CHANGE ORDER

CHANGE ORDER NO.: 8

PROJECT: PB 05-6 PBA Concourse C Gate Expansion

Applicable Drawing(s): SK-A06, SK-A07, SK-A08, SK-A10, SK-A11, SK-A14, SK-A16, SK-A17, SK-A18

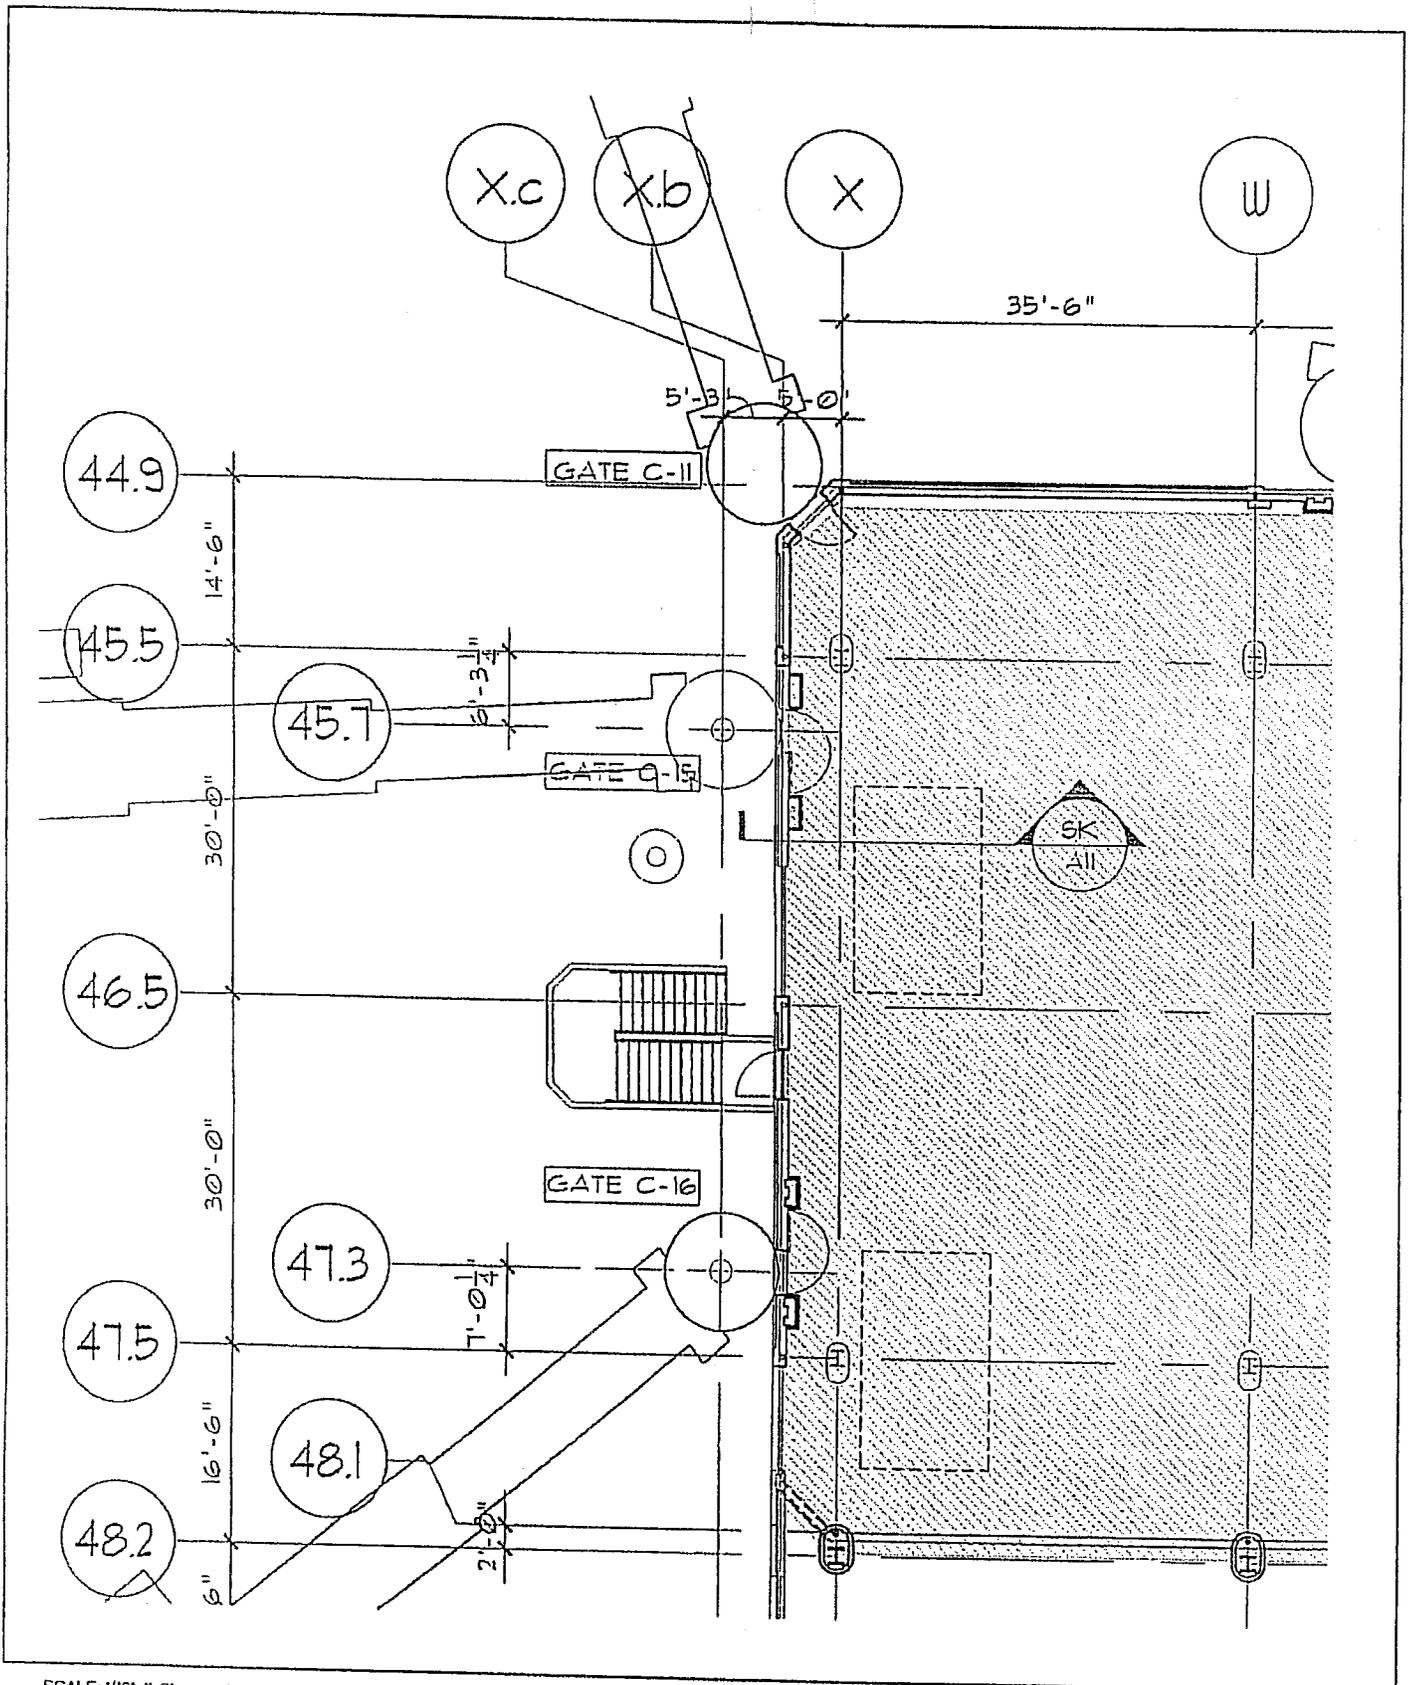
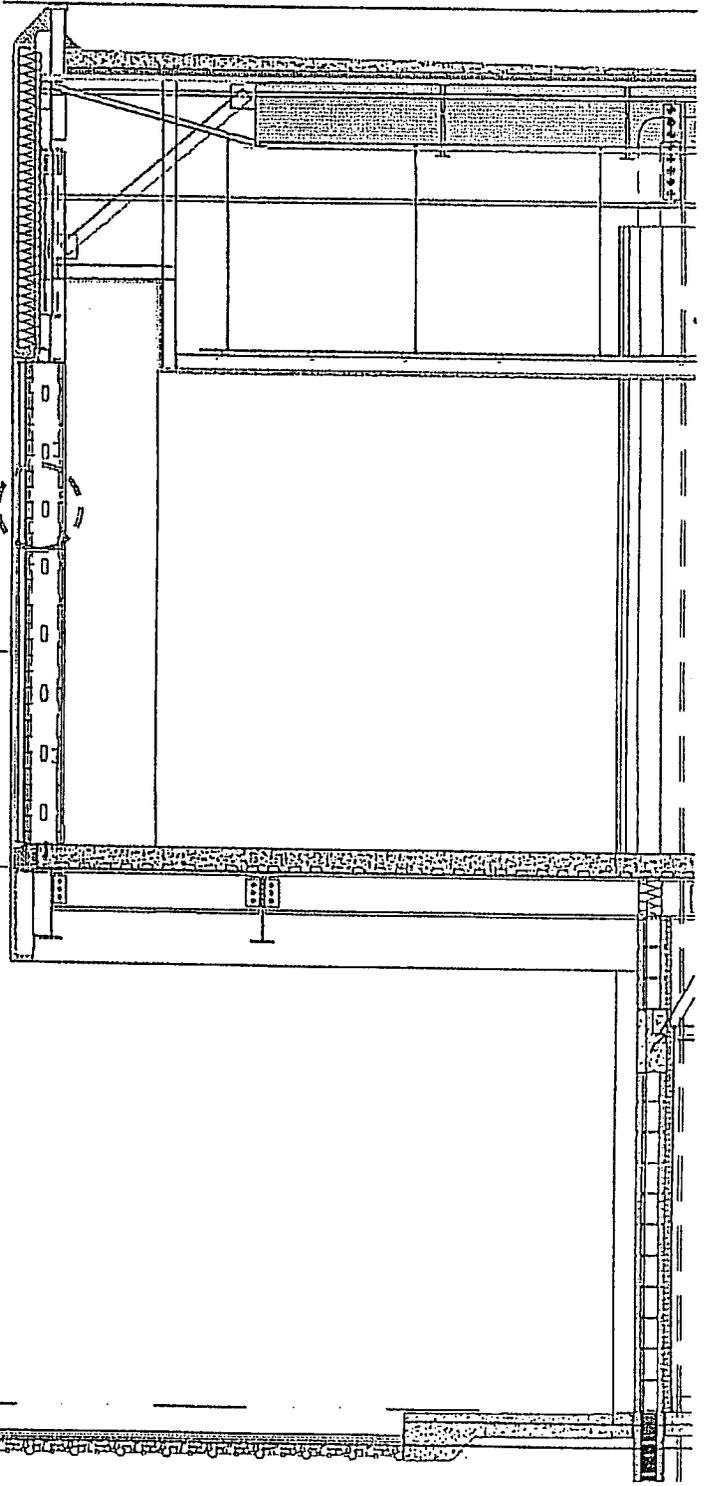
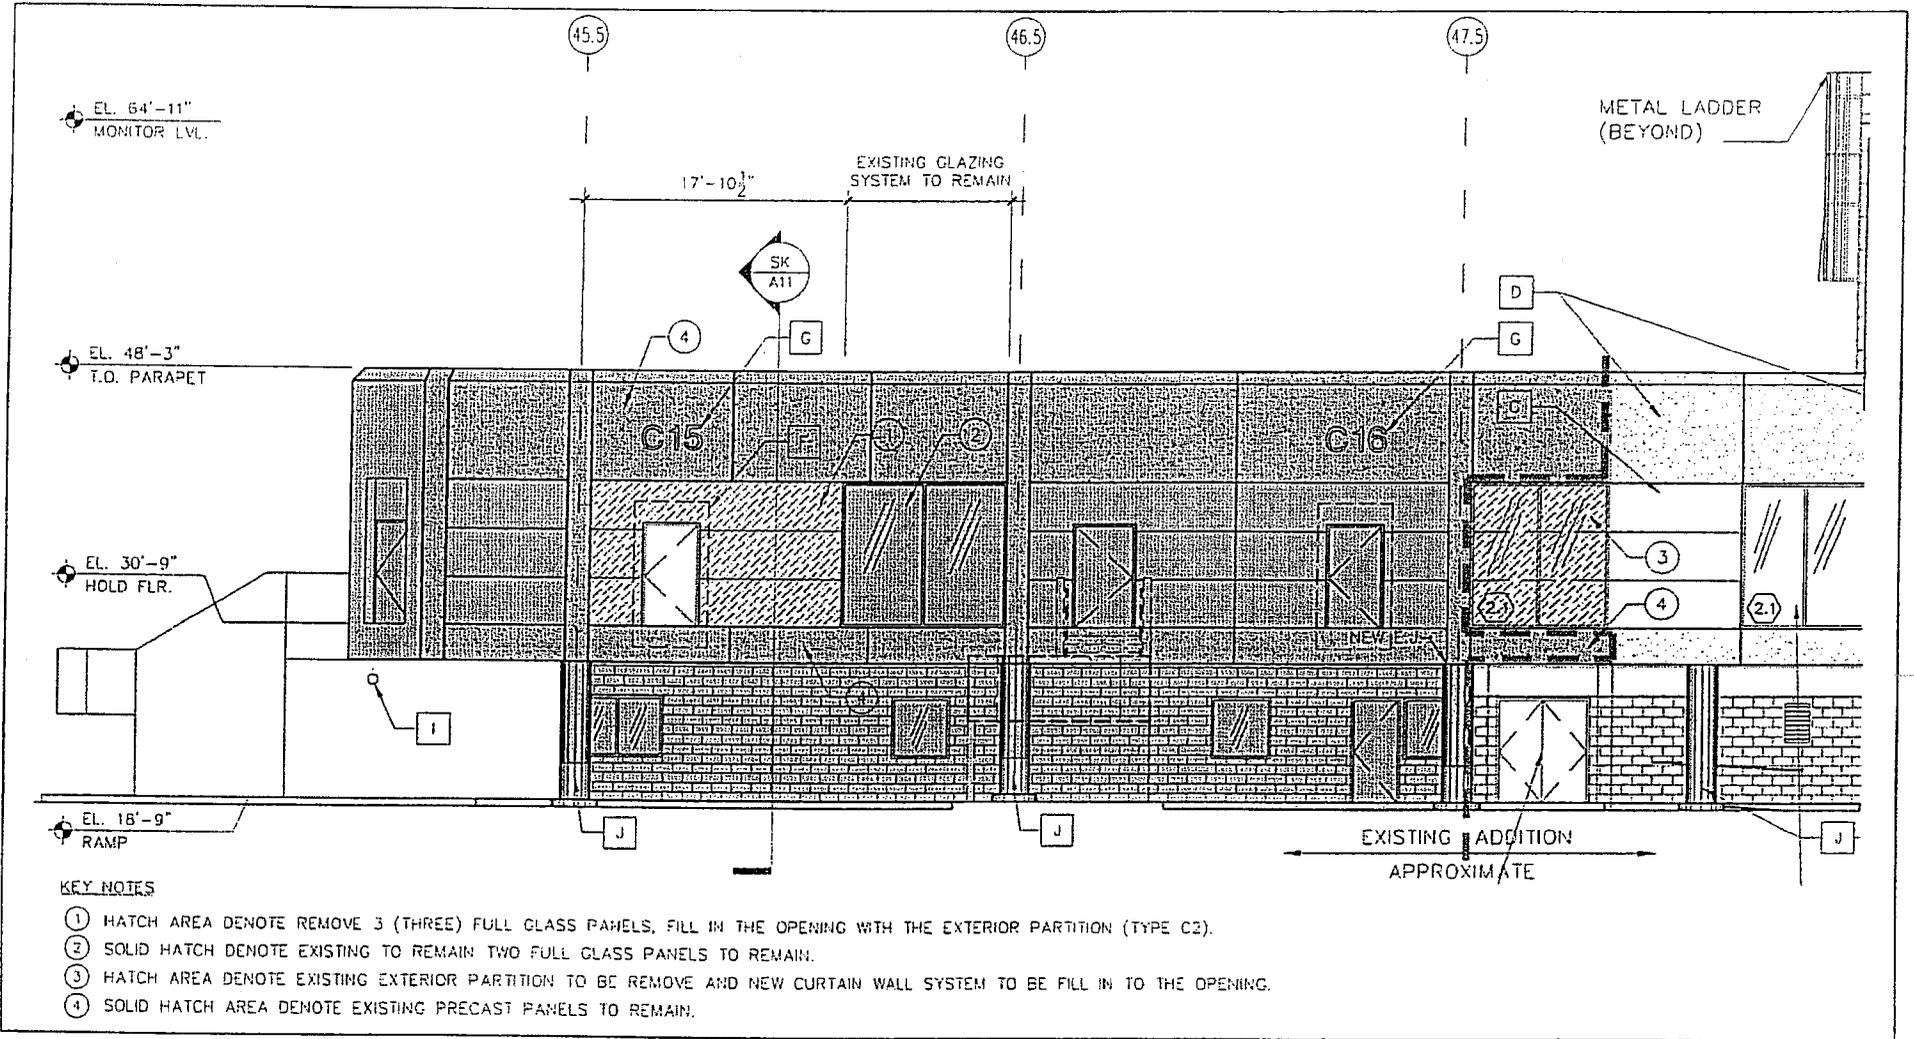
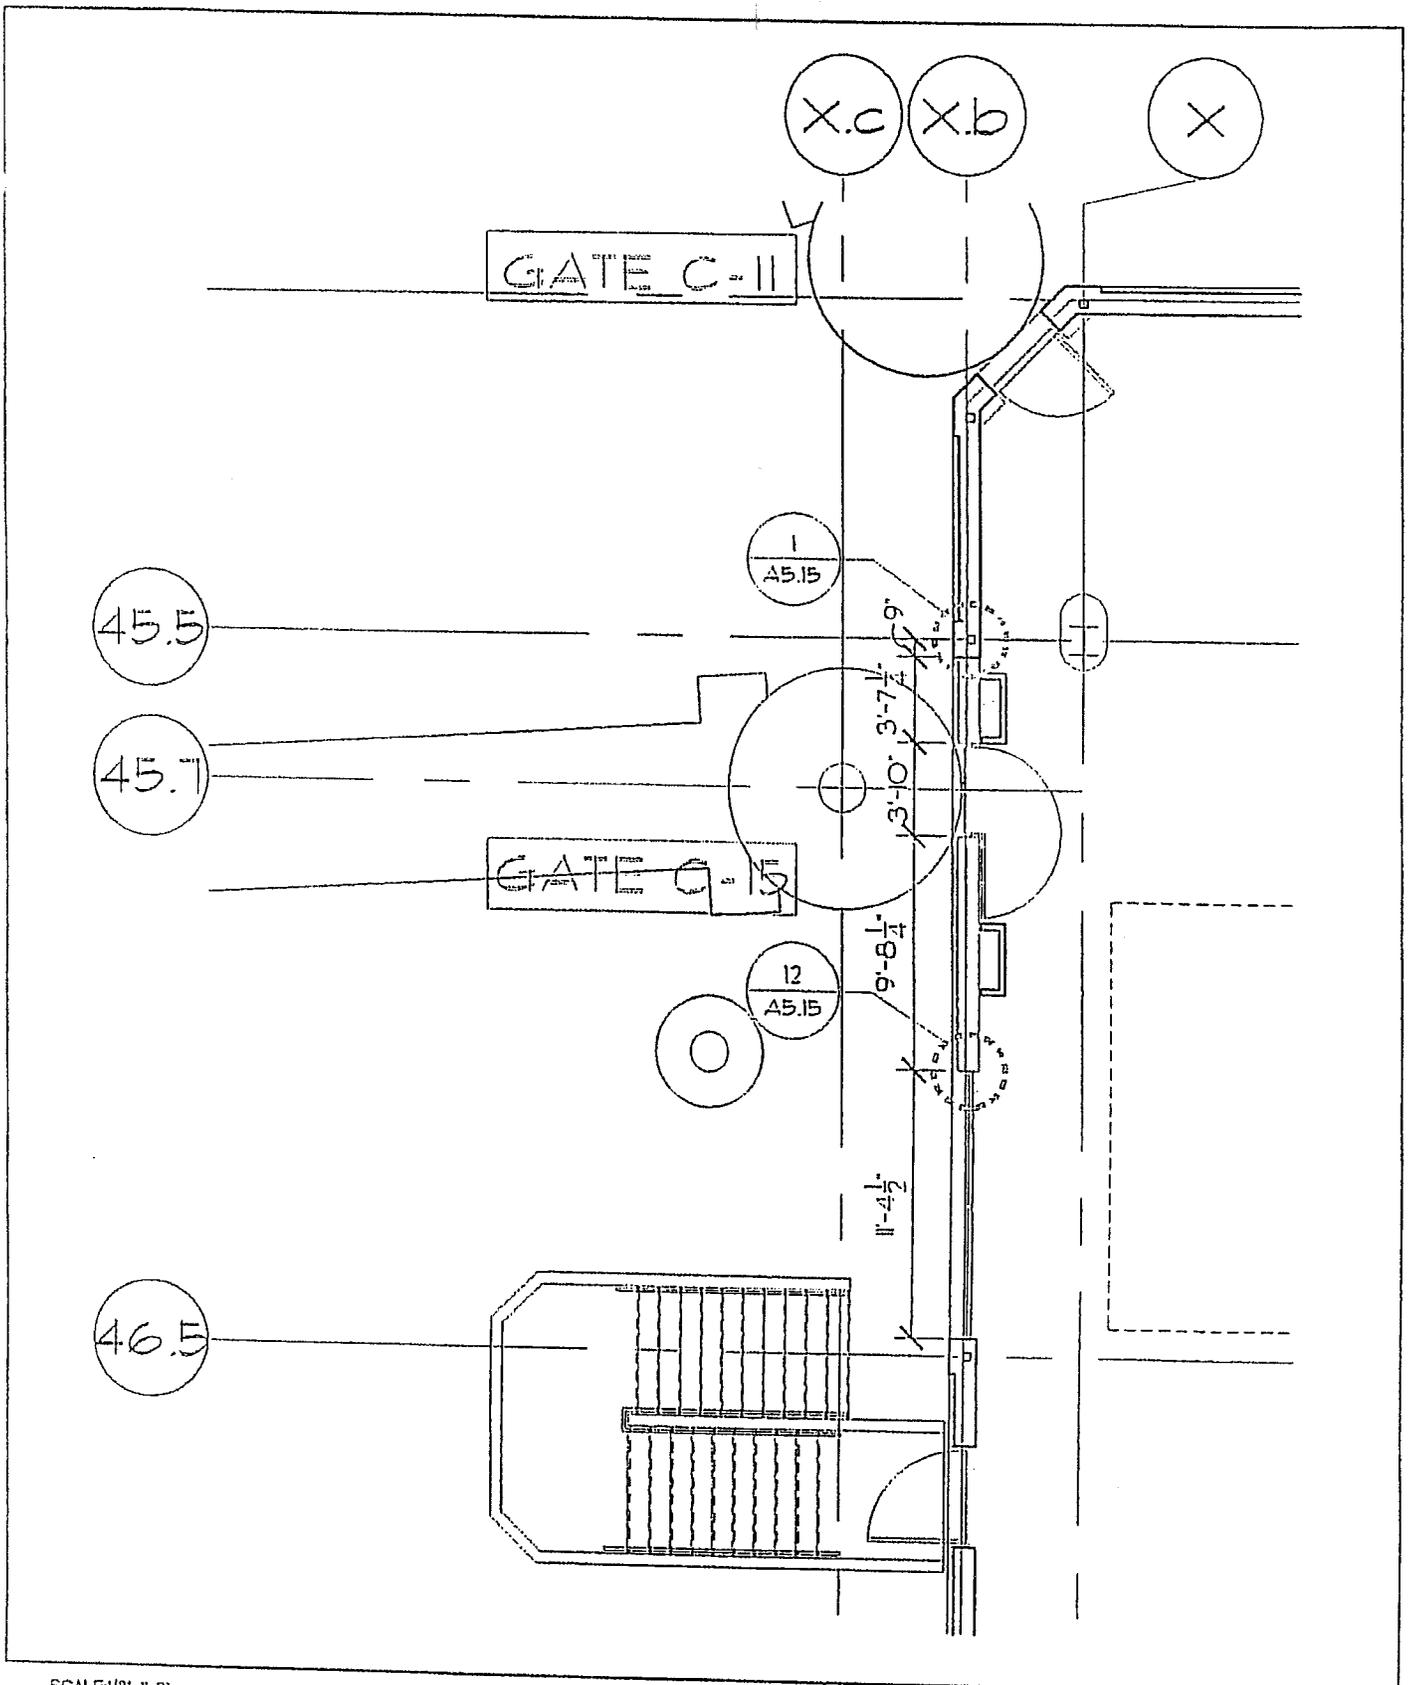
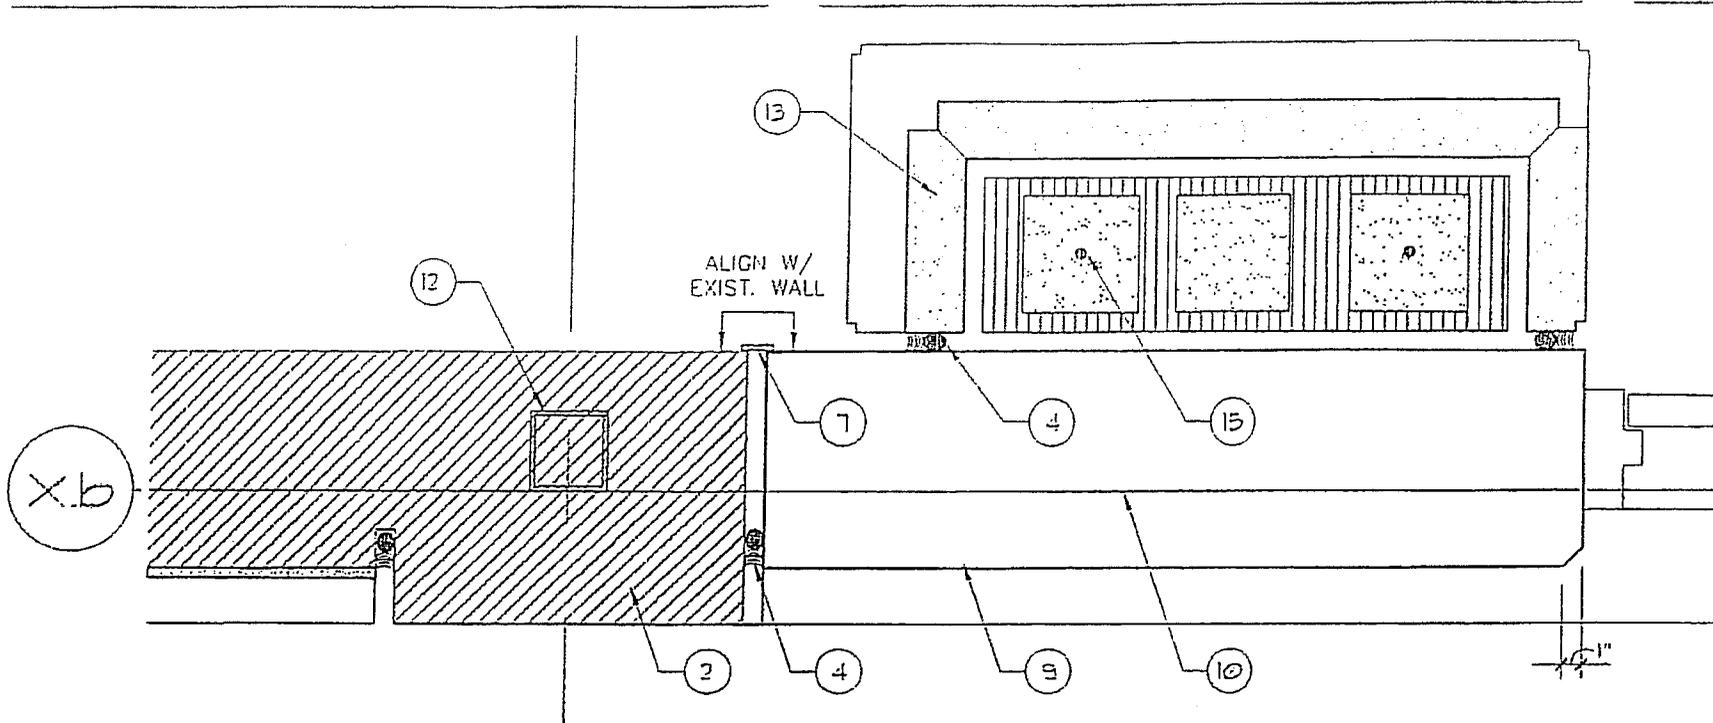
FB Description: Provide curtain wall in lieu of pre cast panels on concourse south wall

The attached sketch plans, sections, elevation and details define the revisions to the design of the new portions of the south wall of concourse 'C'.
